Technical Service Bulletin: tsb090047	Released Date: 16-Jun-2009
Incorrectly Labeled Second Piston Rings

Incorrectly Labeled Second Piston Rings

Figure 1, Piston Ring Part Number

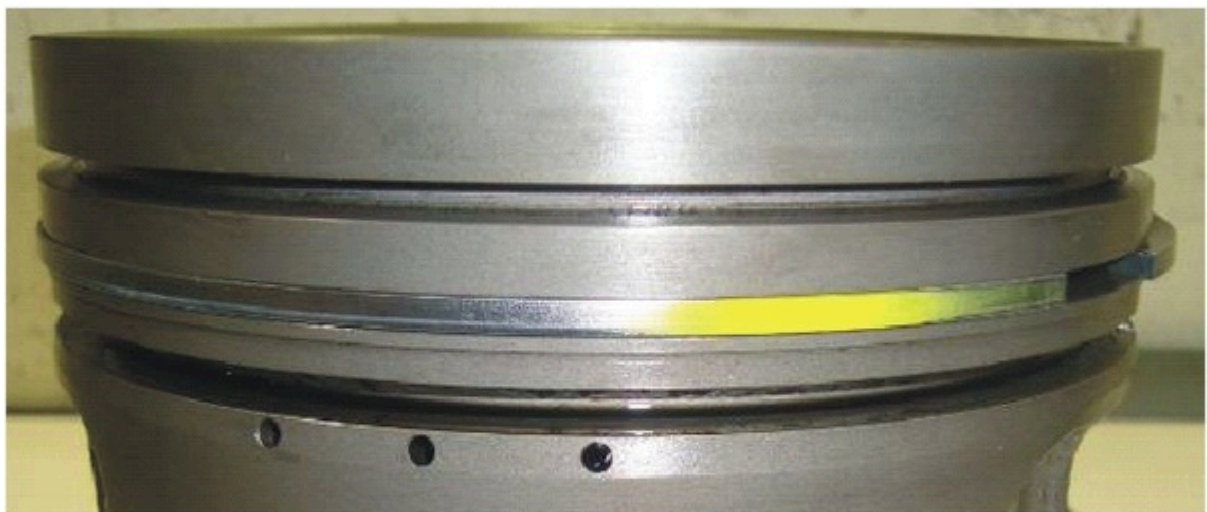
Any piston ring labeled with Part Number 3090460 (see Figure 1 in the Repair Instructions) could be labeled incorrectly. Part sets or kits which include this ring in them are Part Numbers 4025115, 4025116, 4089247, 4089500, 4924652, 4924653, 4955790, 4955910, 4955975, and 4956091.

Figure 3, Incorrectly Labeled Ring

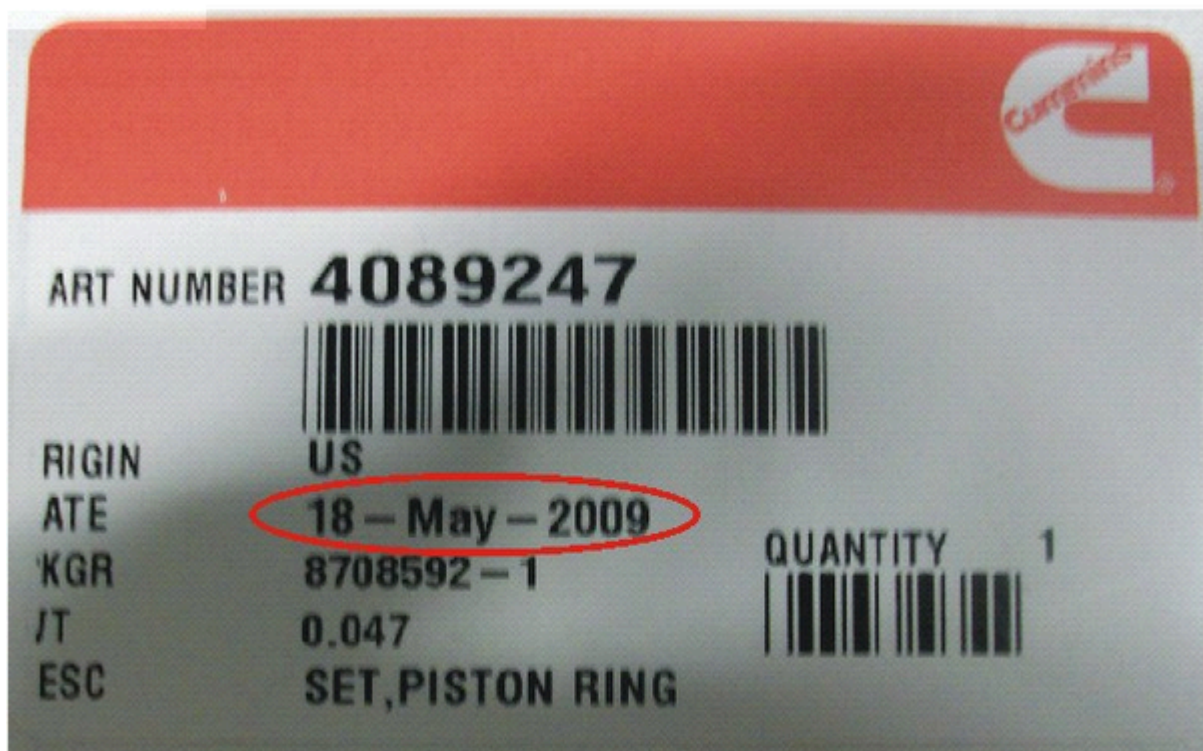
Inspect the piston ring for a paint mark on the outer diameter. If it is marked with yellow paint, it was labeled correctly and can be used normally. If it is marked with blue paint, this ring has been mislabeled and can **not** be used (see Figures 2 and 3 in the Repair Instructions).

Piston ring, Part Number 3068813, was manufactured and labeled with Part Number 3090460 at the supplier, but painted with the correct identification color.

Contact Customer Support and request a Return Goods Authorization (RGA) to return the piston ring set back to the Parts Distribution Center (PDC) from where it was purchased. If the piston ring set was purchased as part of an engine piston kit or overhaul kit, **only** return the piston ring set and keep the remaining parts in the kit.
